CANNONDESIGN

Field Report

DATE	Apr. 10, 2017	**REPORT NO.**	**009**
PROJECT:	Webster University Interdisciplinary Science Building 8274 Big Bend Blvd. Webster Groves, MO 63119	**DATE OF VISIT:** **TIME:** **WEATHER:**	Apr. 04, 2017 3:35 pm 61°F
PROJECT #	004560.01		
PRESENT AT SITE:	Kelvin Patel (CD), Jim Holtrop (AcoustiControl), Jason Szachnieski (Paric)

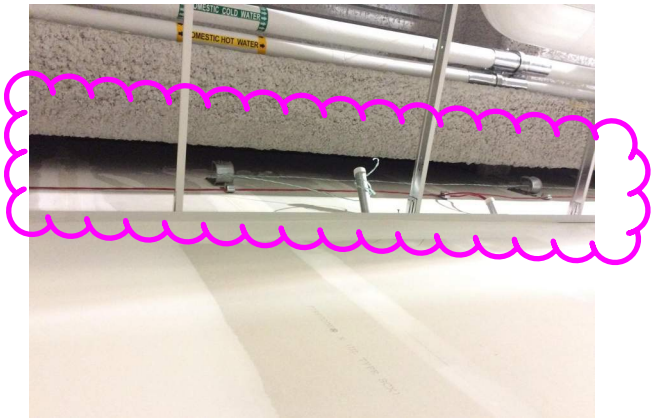
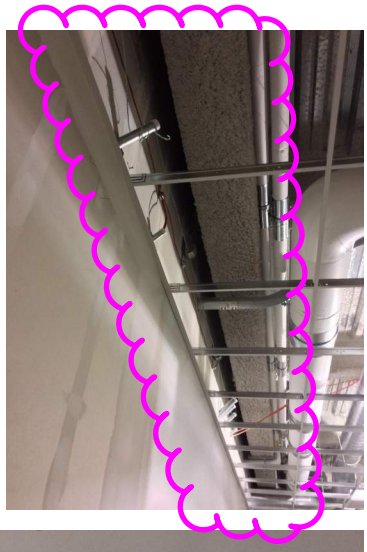
1. At all levels, application of acoustical sealant to seal the top and bottom of partition wall is not continuous with visible gaps/voids. Also, it is absent at some locations like structural beam penetrations along the same walls.
ACTION: All sealant installations per specification 079200. Refer to upcoming Acoustical engineer's report for more comments.

SEAL STRUCTURAL PENETRATIONS

SEAL PARTITION END ABOVE CEILING

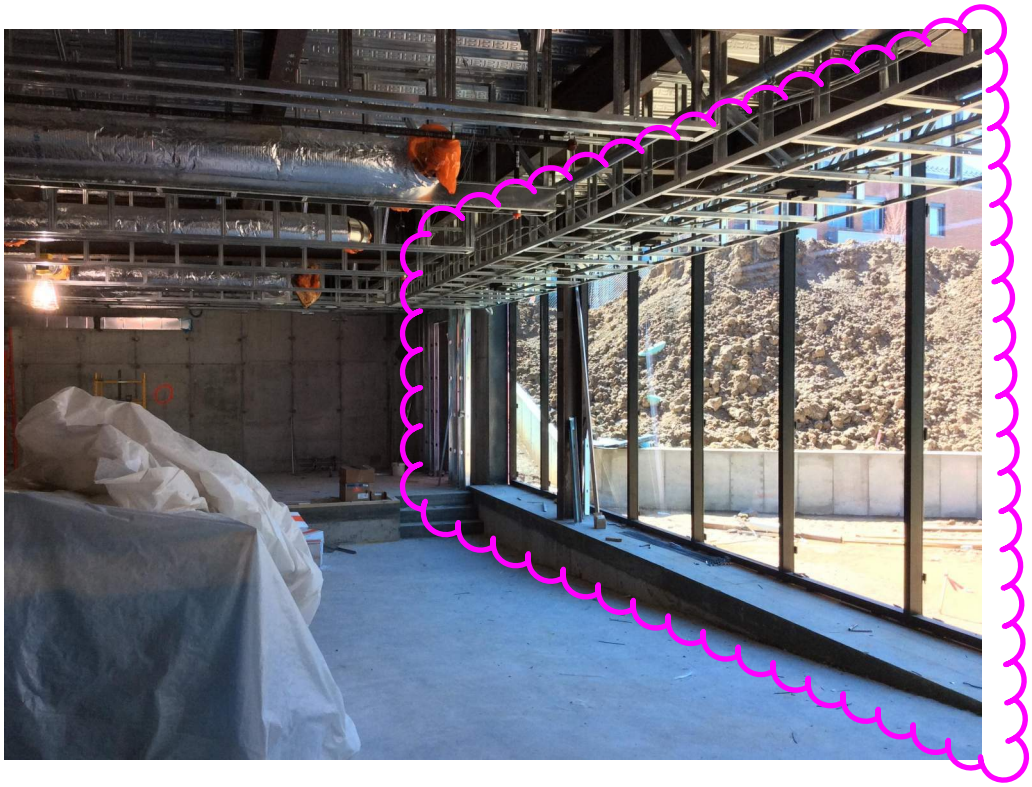
2. At level 01, Curtainwall type EGS-2A at Lecture Hall, the bottom mullions appears to be rotated and improperly installed.
ACTION: Contractor to remediate.

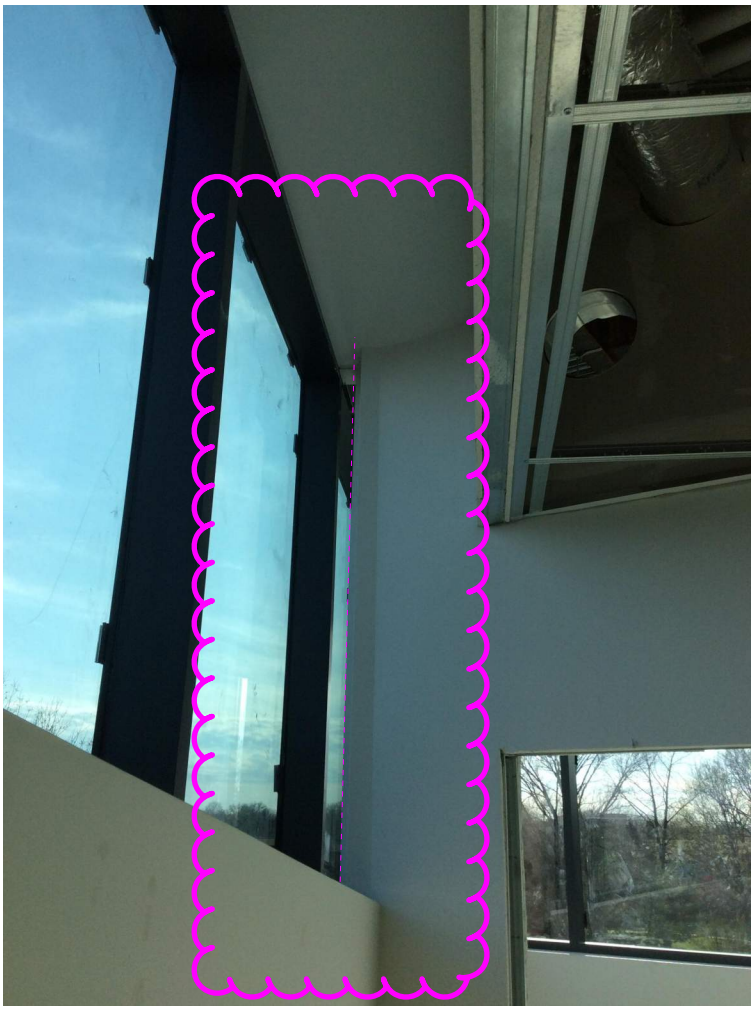
3. At room 342 on level 03, the partition wall ending at curtainwall on south appears to be curving inward and not leveled vertically.
ACTION: Contractor to remediate.

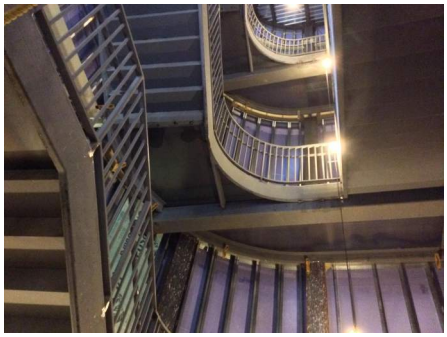
5. At all floor levels, as noted in previous field reports too, temporary protection for curtainwall mullions missing at many locations.
ACTION: Provide temporary protection to protect curtainwall mullion surface finish from damage due to construction activity.
